# City of Bay Minette

### **\*\*REVISED\*\* AGENDA**

### Planning Commission - Site Plan Staff Report

Case Number: SP-24001

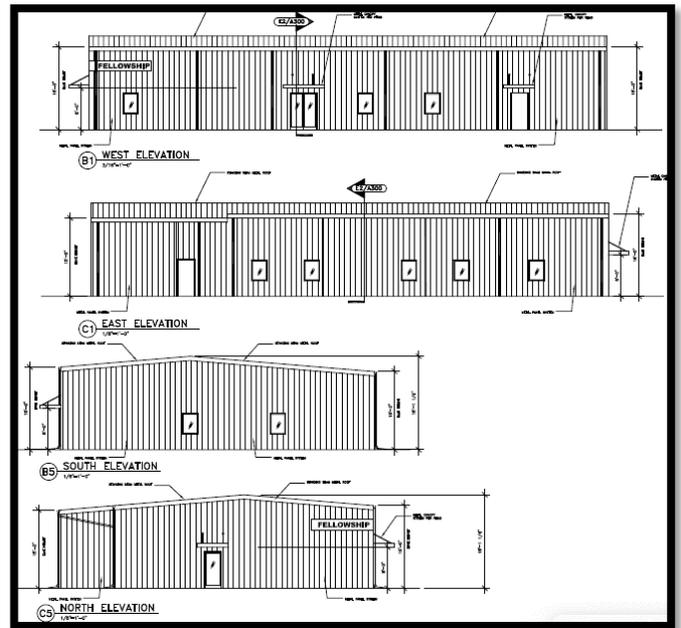
1.) *The density or intensity of land use to be allocated to all parts of the site together with tabulations by acreage and percentages thereof itemized by use and density. Incomplete / Deficient*

The site calculations have not been provided for front/side yard landscaping, off-street parking area, or parking landscape. Calculations for building coverage, impervious surface, open/natural space, and some landscaping have been submitted. This application is incomplete/deficient until all requirements per Section 8.09.06 Minimum Requirements for Submittal e. are received.

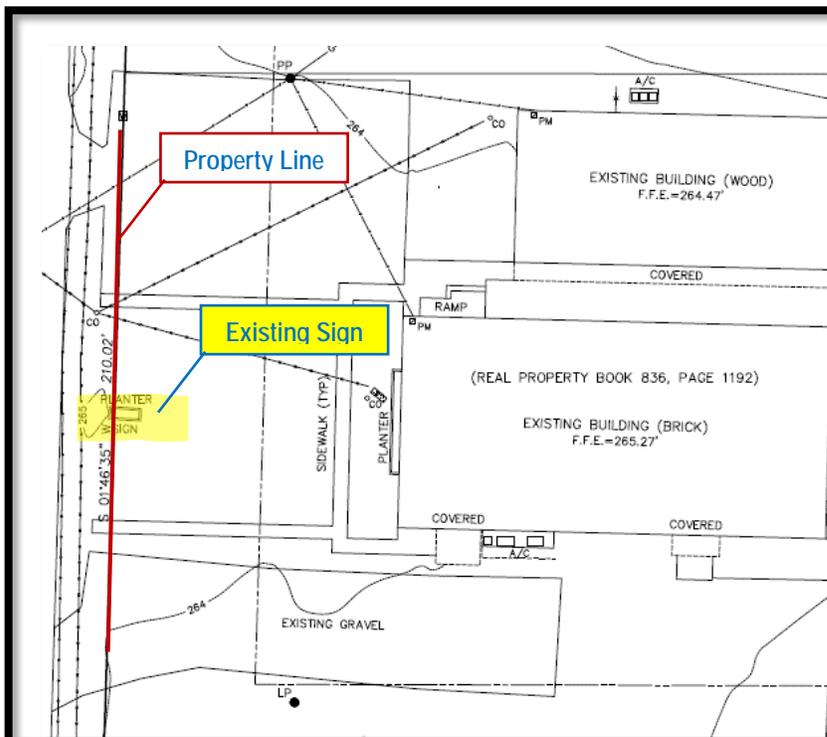
- 9.) *The location and size of all signs to be located on the site. In the event that a sign is pre-existing and fails to conform to the requirements as set forth in this ordinance, site plan approval will be granted only under the condition that all signs will comply with the regulations as set forth in the sign ordinance.*

*Incomplete / Deficient*  
 Current submittals show the existing sign encroaching over the property line into the right-of-way which is prohibited per Section 16.04.08. The site plan layout submitted states the prohibited sign and planter is to be removed. Any signage will require a Sign Permit prior to construction/installation to review compliance with the full sign ordinance.
